THIRD FLOOR

BEDROOM 3/
DRESSING ROOM
(EXISTING BOARDING)

1435 - P135

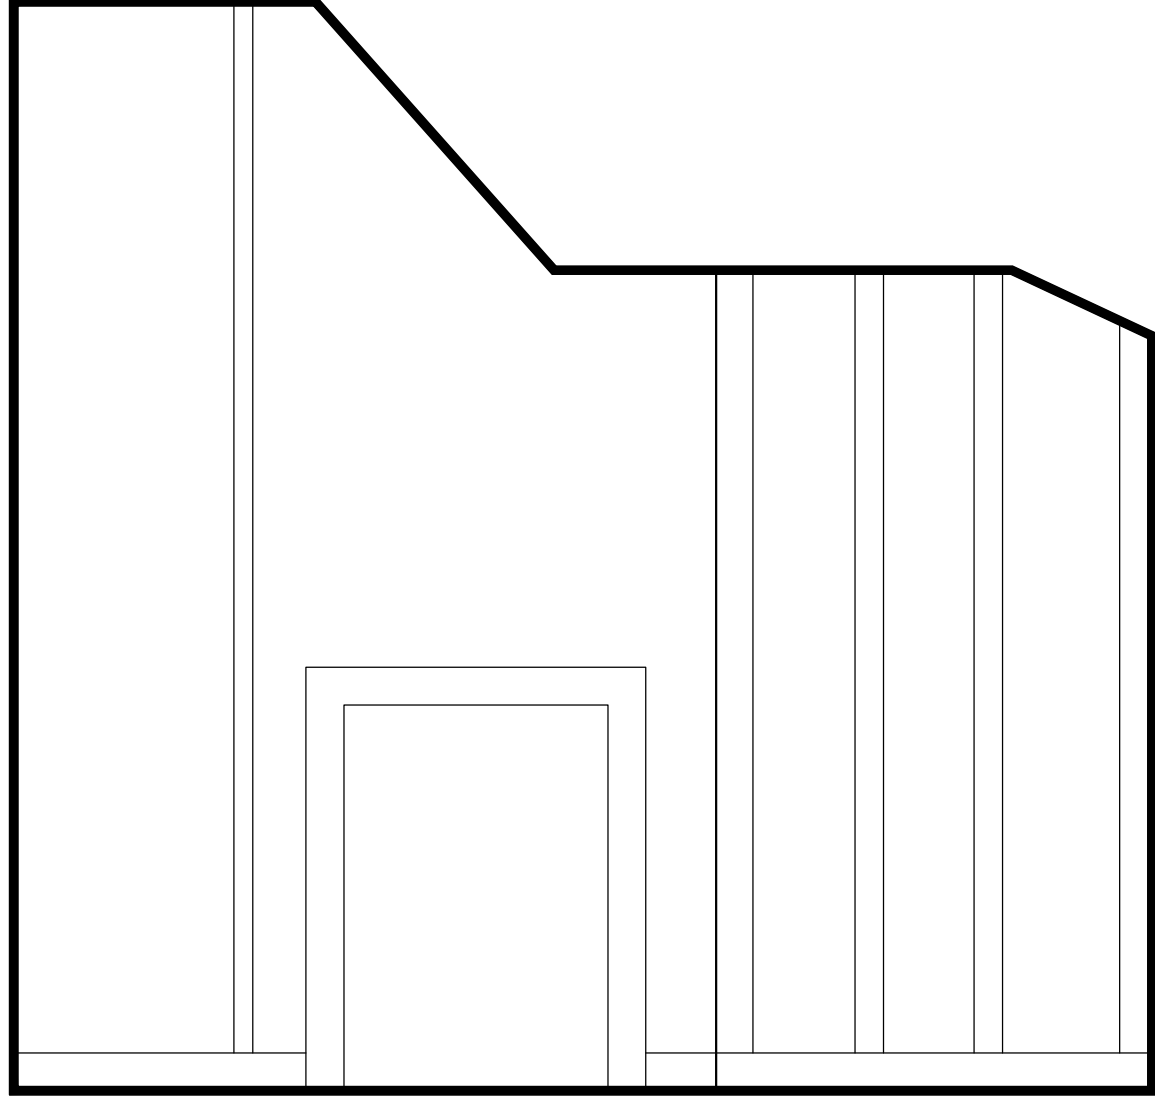
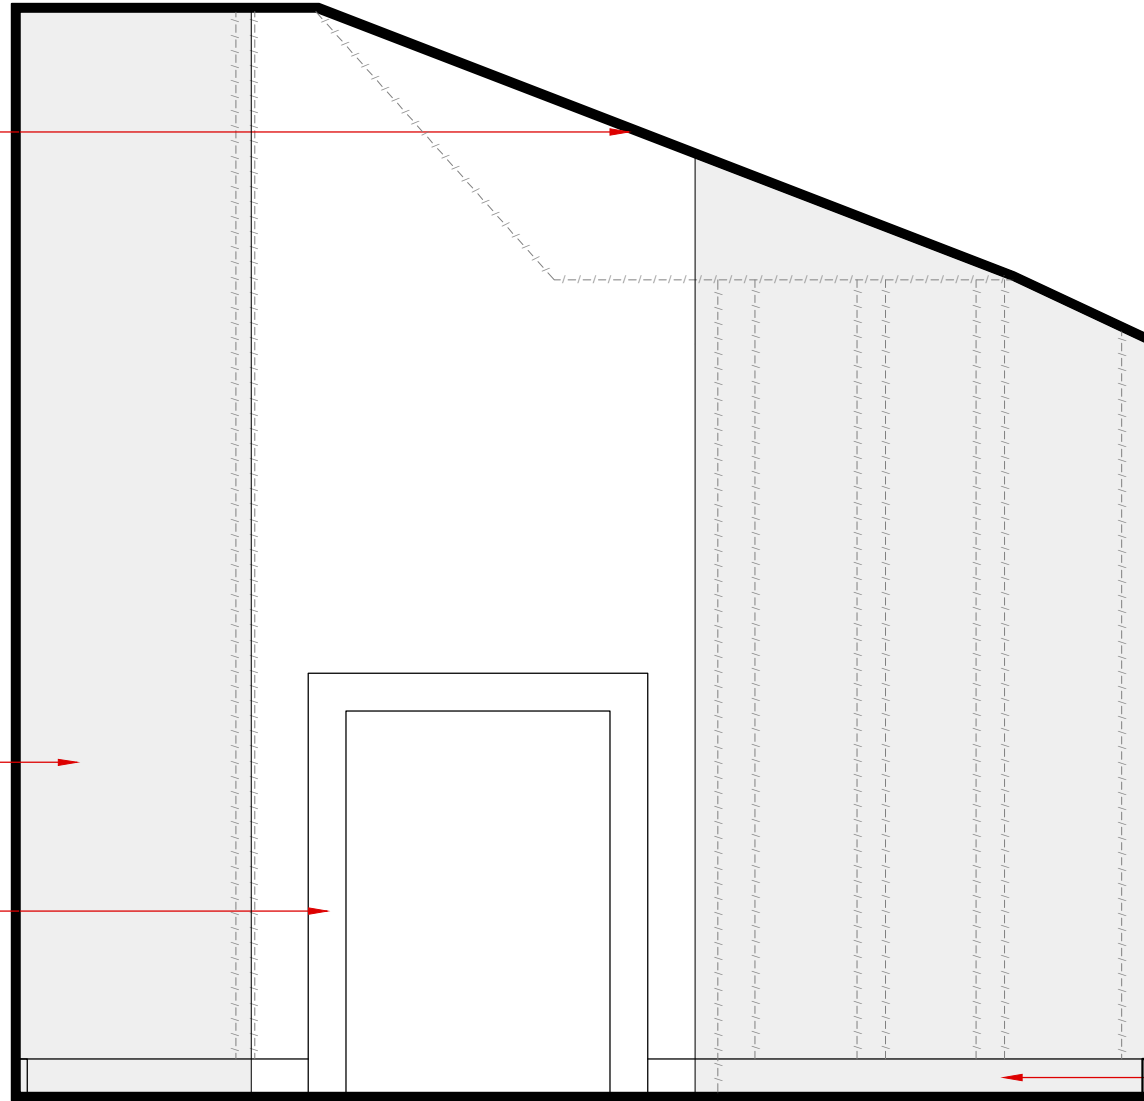
Rev	Date	Notes
A	14.05.15	Note to ceiling revised following comments from council.
B	23.06.15	Room named changed and joinery added

Non original false ceiling removed and replaced to continue slope of ceiling in existing upper part of room. IE continue slope down from existing top down to eaves.

Reinstate fireplace surround.

Proposed boxing to house pipework.
